REQUEST FOR DRB APPROVAL FOR:
PRICE RESIDENCE

DRB21-0722
REVISED FINAL SUBMITTAL 11/22/2021
NOVEMBER 2021 AGENDA

1649 W 22ND STREET, MIAMI BEACH, FL 33140

WATERSIDE FACADE
AS SUBMITTED

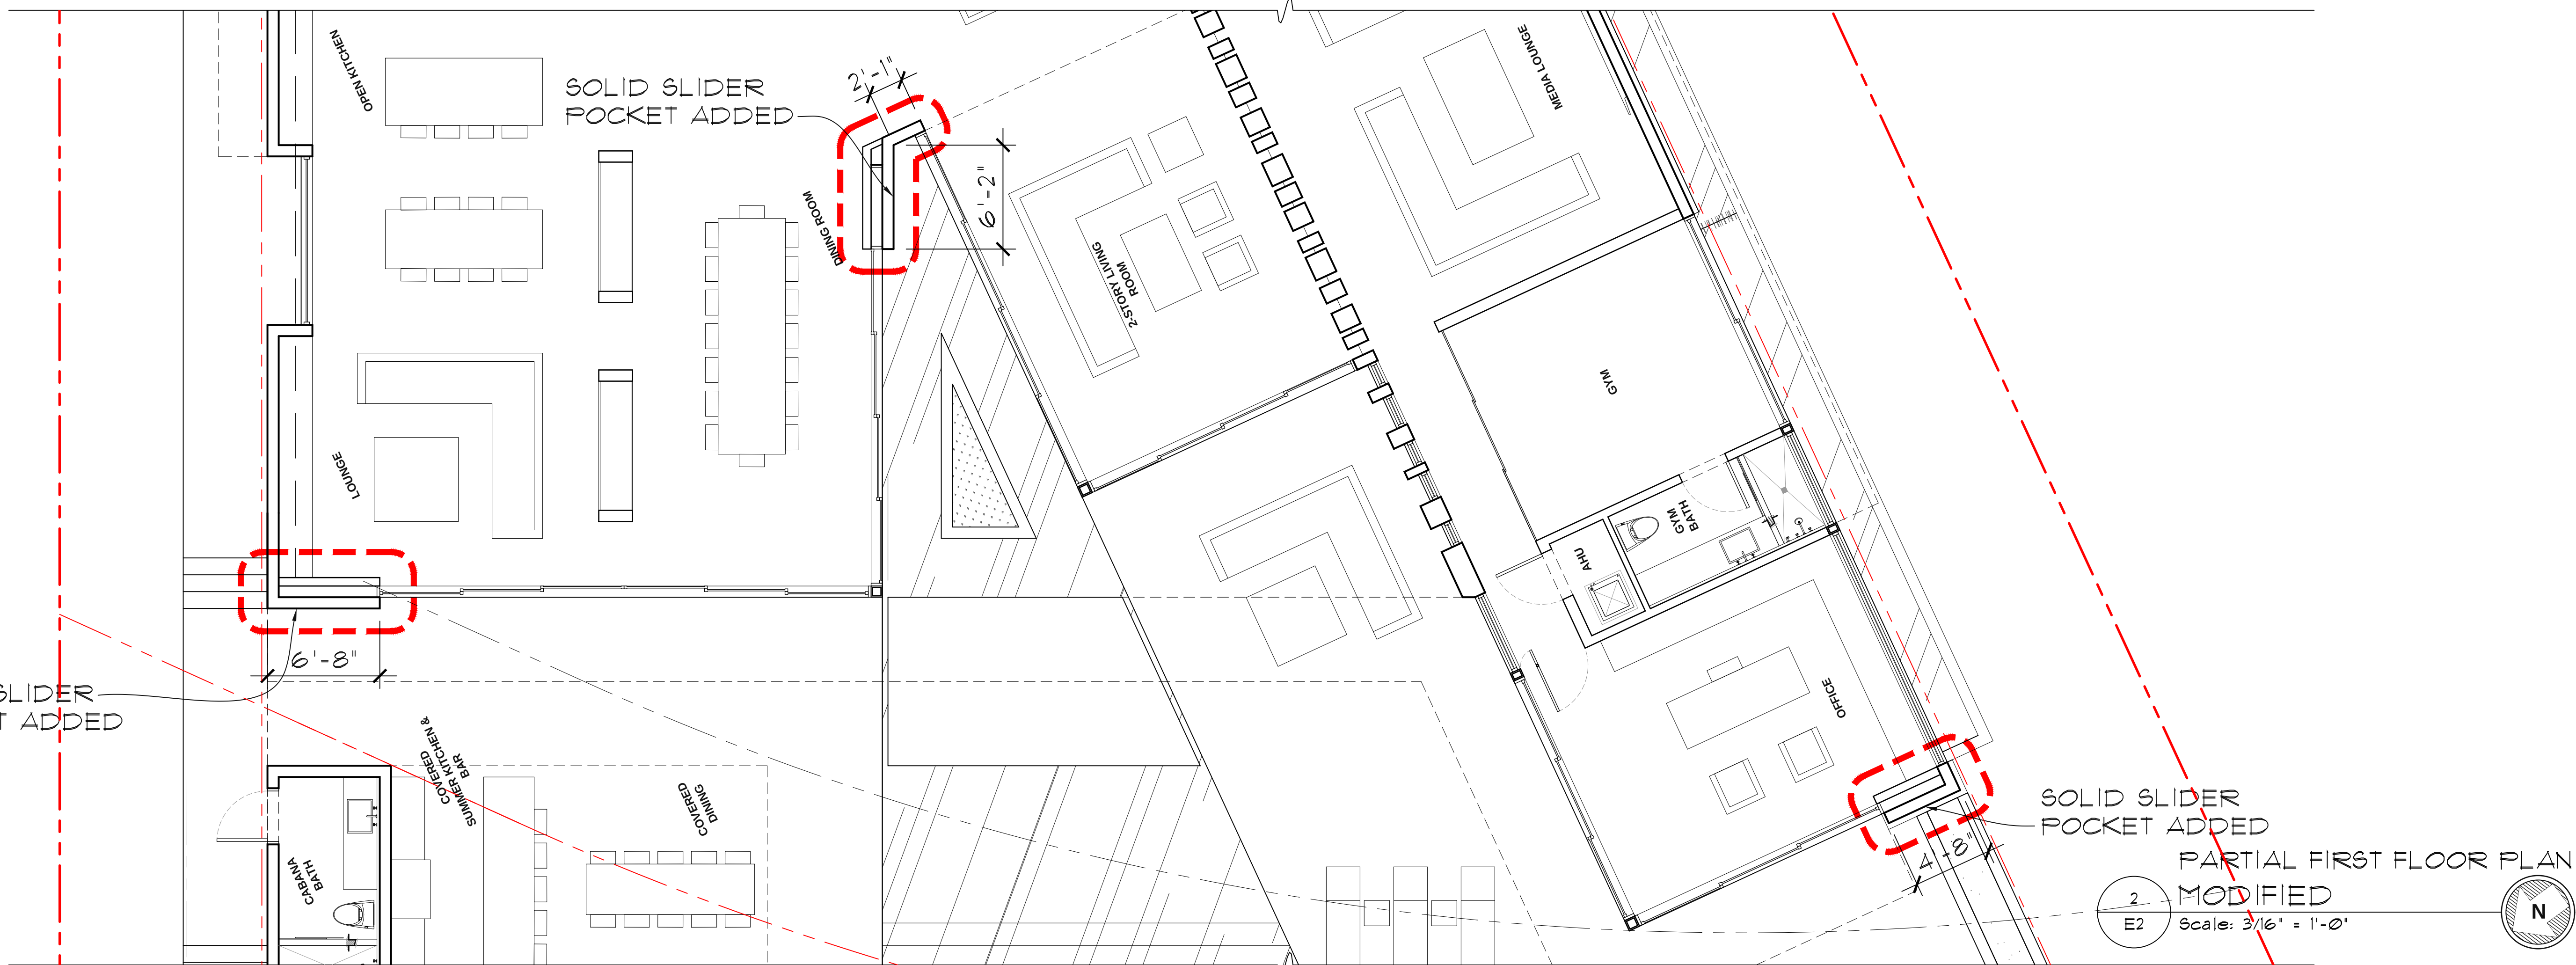
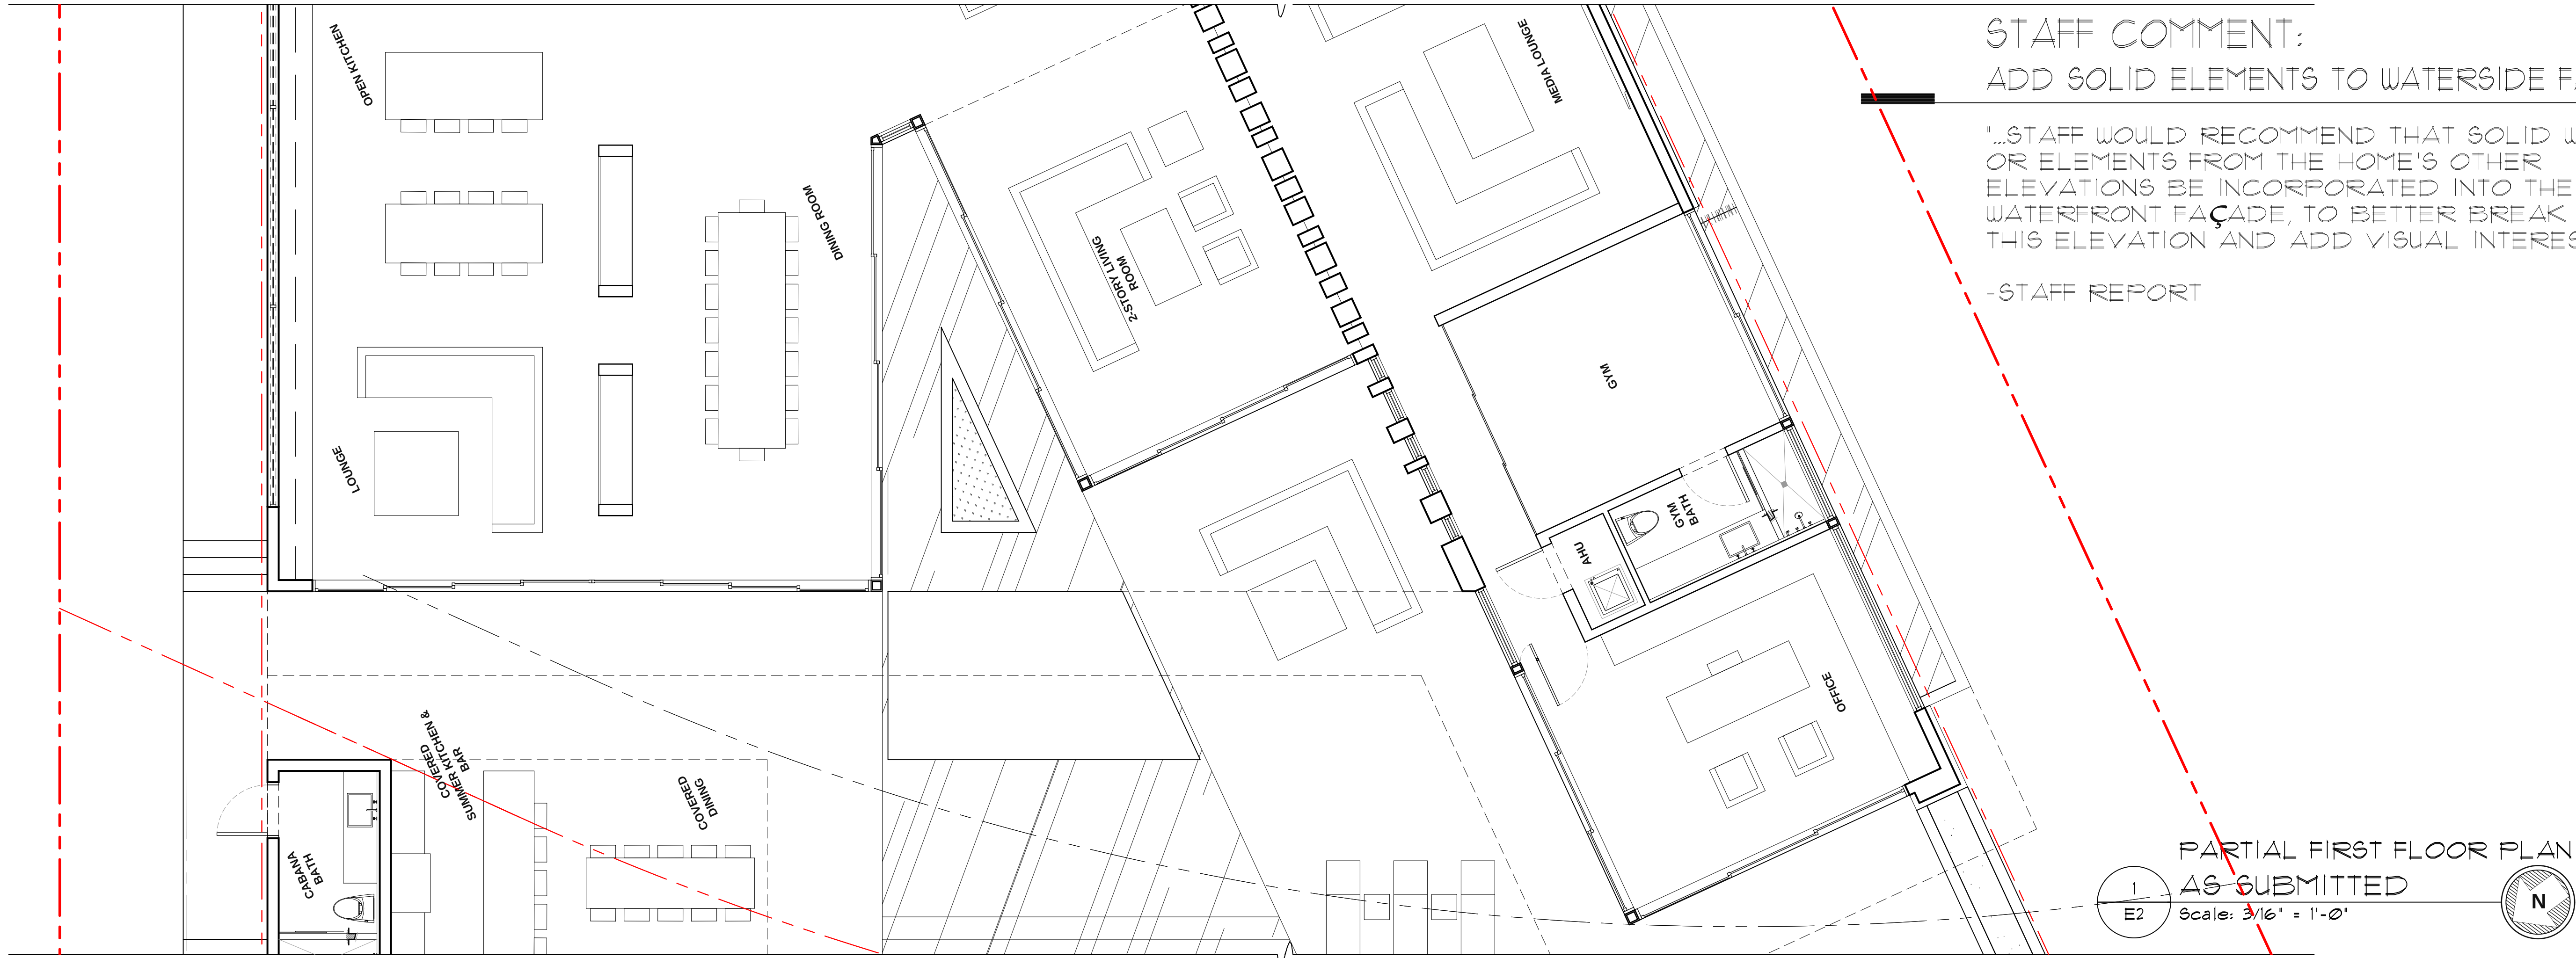
STAFF COMMENT:
ADD SOLID ELEMENTS TO WATERSIDE FACADE

"...STAFF WOULD RECOMMEND THAT SOLID WALLS OR ELEMENTS FROM THE HOME'S OTHER ELEVATIONS BE INCORPORATED INTO THE WATERFRONT FACADE, TO BETTER BREAK UP THIS ELEVATION AND ADD VISUAL INTEREST."

WATERSIDE FACADE
MODIFIED

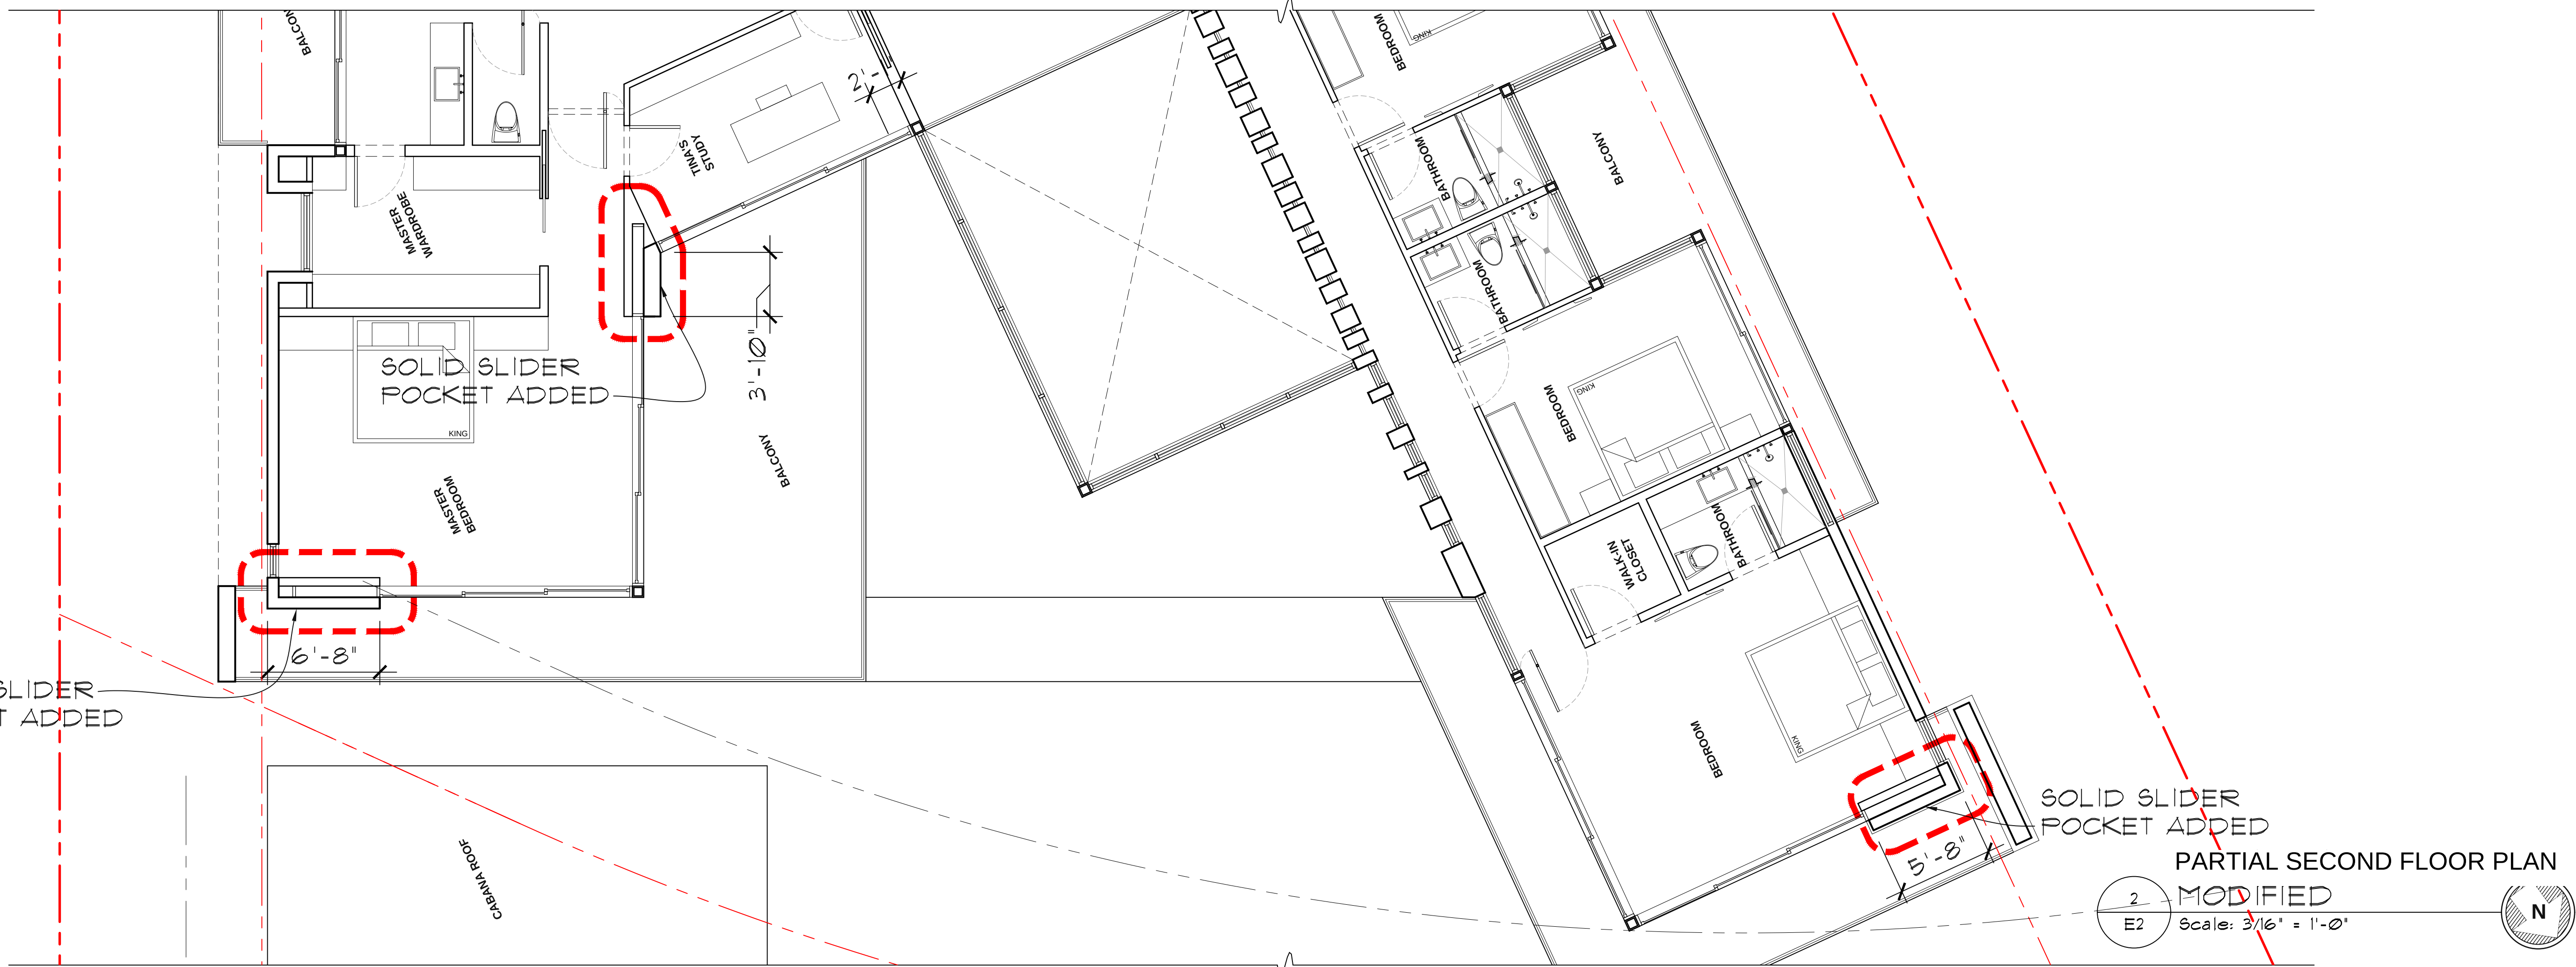
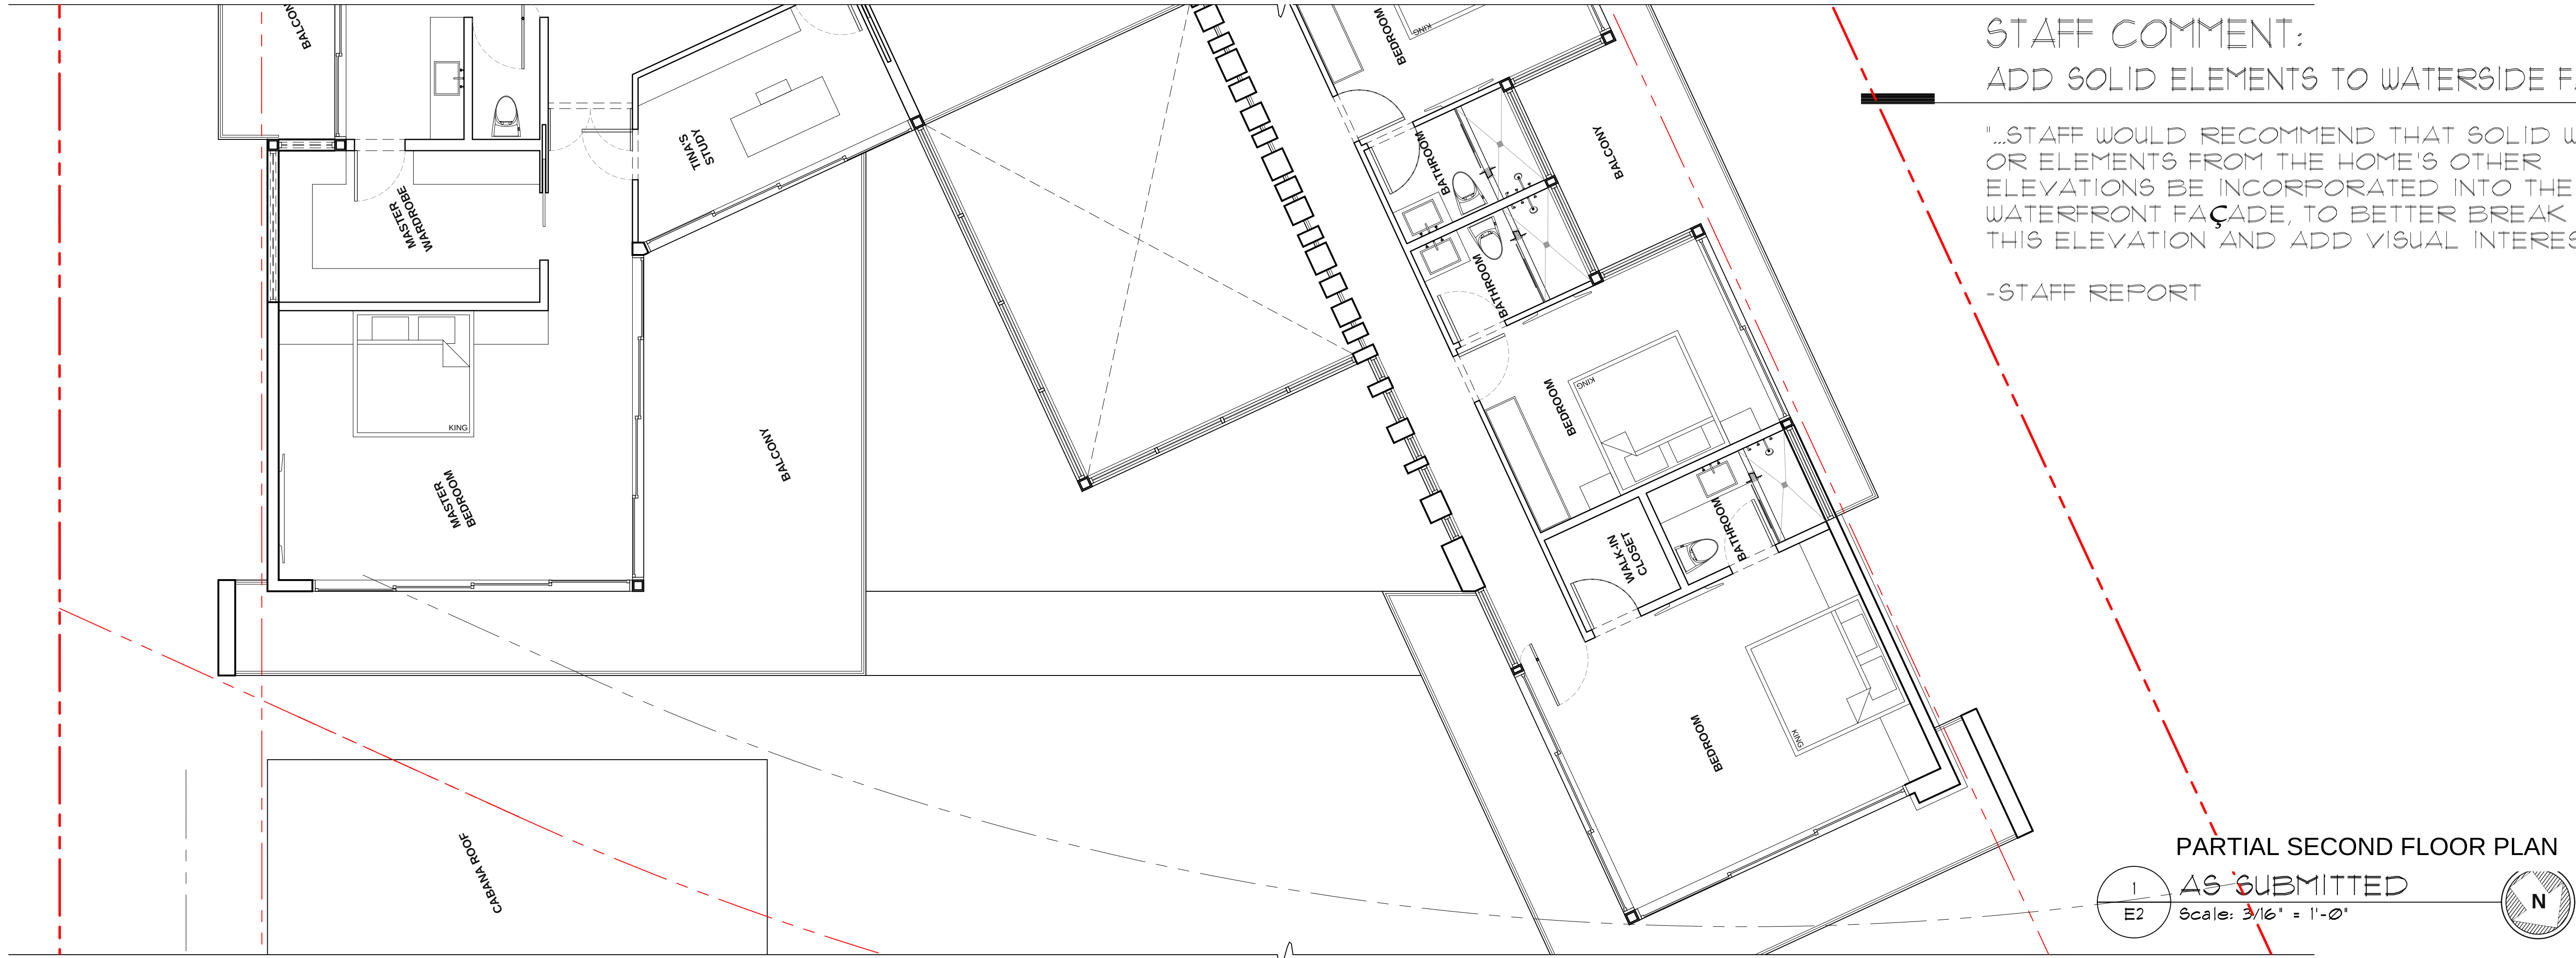
STAFF COMMENT:
ADD SOLID ELEMENTS TO WATERSIDE FACADE

"...STAFF WOULD RECOMMEND THAT SOLID WALLS OR ELEMENTS FROM THE HOME'S OTHER ELEVATIONS BE INCORPORATED INTO THE WATERFRONT FACADE, TO BETTER BREAK UP THIS ELEVATION AND ADD VISUAL INTEREST."
